Model type:
IDL55EU.2

Commercial code:
F032215

Notices

N1045072FIG1

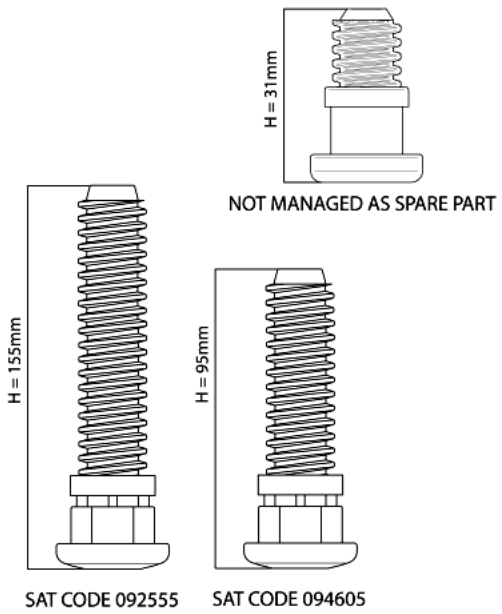
N1045072: Introduction of fixed rear foot H=31mm on free-standing models.

From serial no. 40218.0001, free-standing dishwashers affected by this modification have been equipped with new fixed rear feet (H=31mm).
The new foot replaces the adjustable one (H=155mm) Service code 092555; on the EVO3 range with TurboDry the new foot replaces the adjustable foot (H=95mm) Service code 094605.
The Spare Part Warehouse will continue to manage only 155mm and 95mm adjustable feet as they are interchangeable with the fixed 31mm foot.
The three feet are shown in illustration N1045072FIG1.

N1045083FIG1

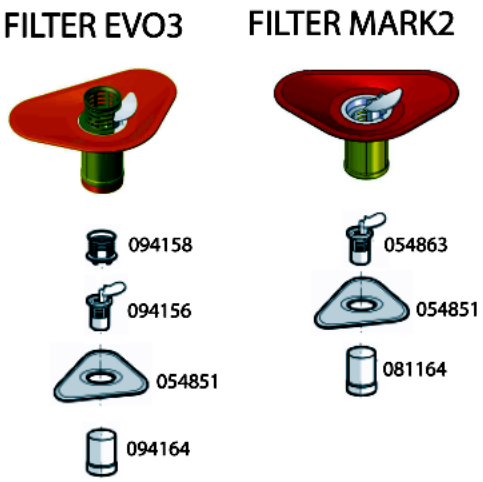
n1045083: Modification of filters on EVO3 60 cm dishwashers

All dishwasher models affected by this modification have been equipped with the items listed below, in order to solve the drain pump clooging problem.

Introduction of:
Cylindrical plastic filter code 081164
Central filter code 054863

Elimination of:
Cylindrical plastic filter code 094164
Central filter code 094156
Central filter grid code 094158

The modification has been introduced progressively, starting from serial no. 40516.0001.

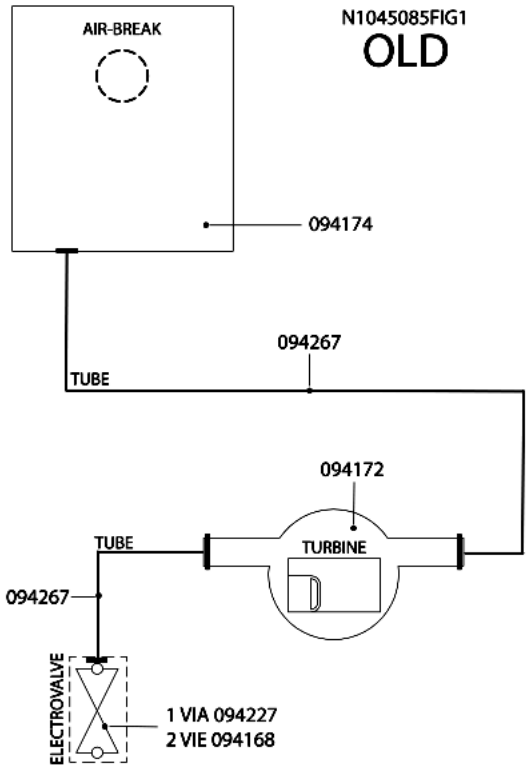
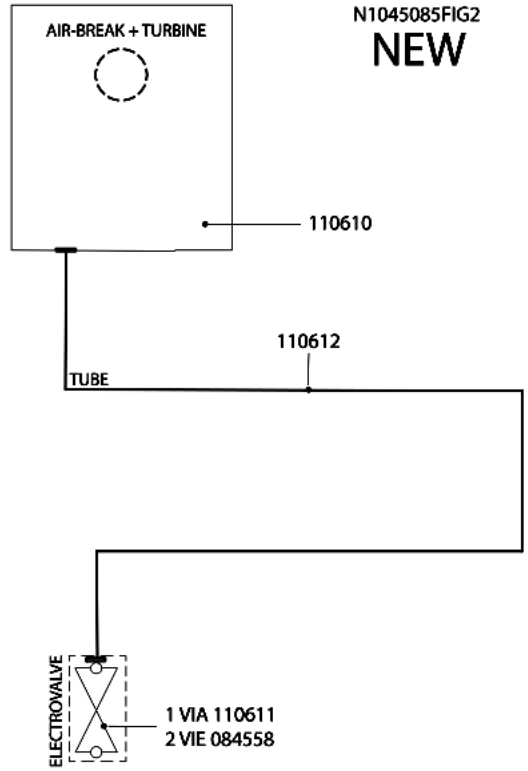
n1045085: Introduction of new litre counter turbine integrated on air-break.

All dishwashers affected by this note have been equipped with a new litre counter turbine on the air-break.
Picture N1045085FIG1 illustrates the premodification structure, picture N1045085FIG2 the new structure.

Items affected by the modification.

AIR-BREAK:
new 110610;
premodification 094174;
the new item features a new integrated litre counter turbine and its water supply hose has a smaller diameter.

LITRE COUNTER TURBINE code 094172 has been eliminated.

SOLENOID VALVES:
new:
1-WAY code 110611;
2-WAY code 084558(Rohs 143737);
premodification:
1-WAY code 094227;
2-WAY code 094168;
the new solenoid valves have a smaller diameter drain hose fitting.

HOSES:
new solenoid valve hose/air-break code 110612;
premodification turbine hose/air-break code 094267;
premodification solenoid valve hose/air-break code 094267;
the new hose has a smaller internal diameter.

WIRING:
the litre counter turbine connecting cable is longer, but since the connector is the same, the new item can be used in place of the premodification one.

N1045133/134FIG1

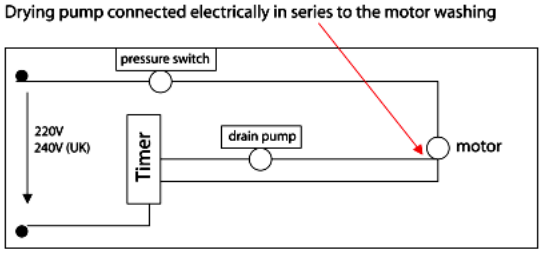
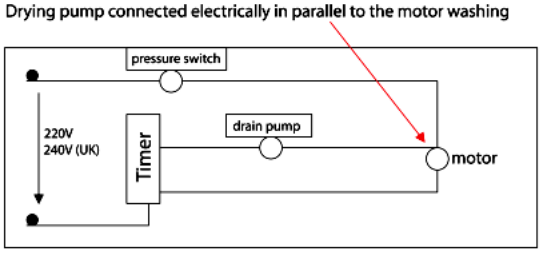
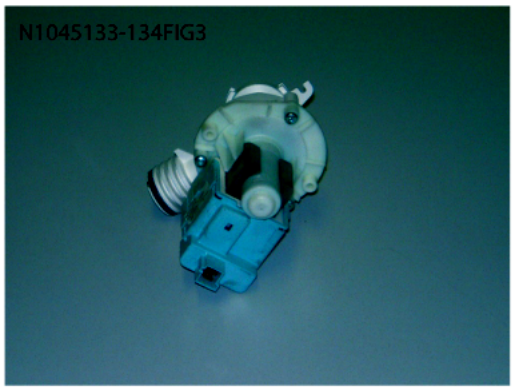
n1045133: New thermoprotected drain pump in parallel with wash electric pump

The drain pump electrical connection has been modified from a configuration in series with the wash electric pump to one in parallel.

The drain pump in series with the wash electric pump is fed through the wash electric pump causing a voltage drop equal to -15V (diagram N1045133-134FIG1).

The drain pump in series with the wash electric pump is electrically fed directly by the F-N line, without any voltage drop (diagram N1045133-134FIG1).

New parts:
Wiring in parallel
C00118767(Rohs 143766) - thermoprotected drain pump 220/240V 50HZ 26W - picture (N1045133-134FIG3)

Premodification parts:
Wiring in series

C00112306(Rohs 143739) - drain pump 230V 50HZ 22W - picture (N1045133-134FIG4)

Important!!
The thermoprotected drain pump cannot be installed on premodification dishwashers.
The non-thermoprotected drain pump cannot be installed on modified dishwashers.

N1045136FIG1

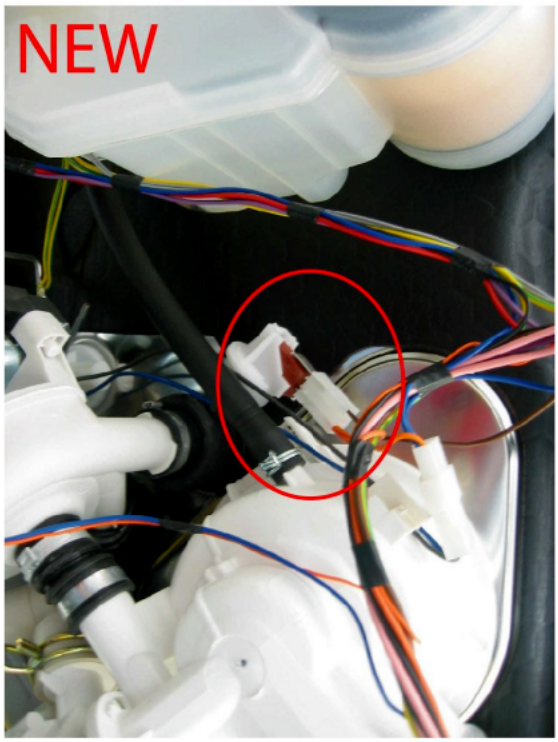
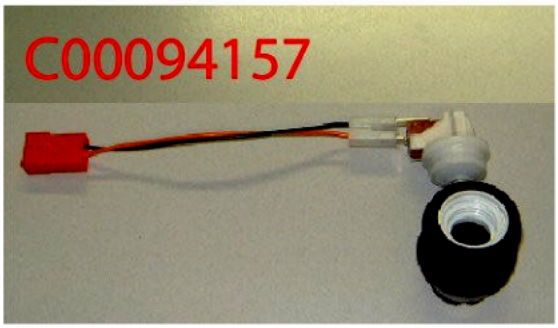
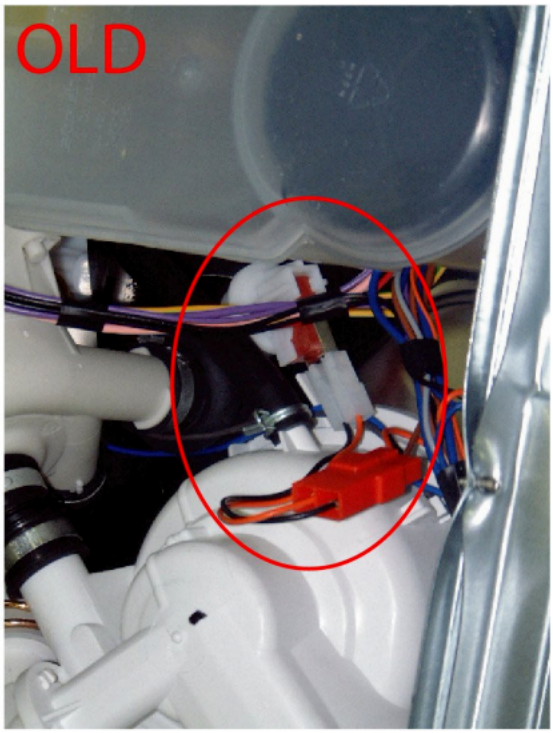
n1045136: introduction of new high pressure sensor

In modified products the connector going to the high pressure sensor is part of the wiring assembly (see picture N1045136FIG1).
In premodification products the high pressure sensor is connected to the wiring assembly by a cable that is part of code C00094157 (see pictures N1045136FIG2-3).

New parts
Wiring
C00142435 - high pressure sensor

Premodification parts
Wiring
C00094157 - high pressure sensor + cable

The new parts are not individually interchangeable with premodification ones.
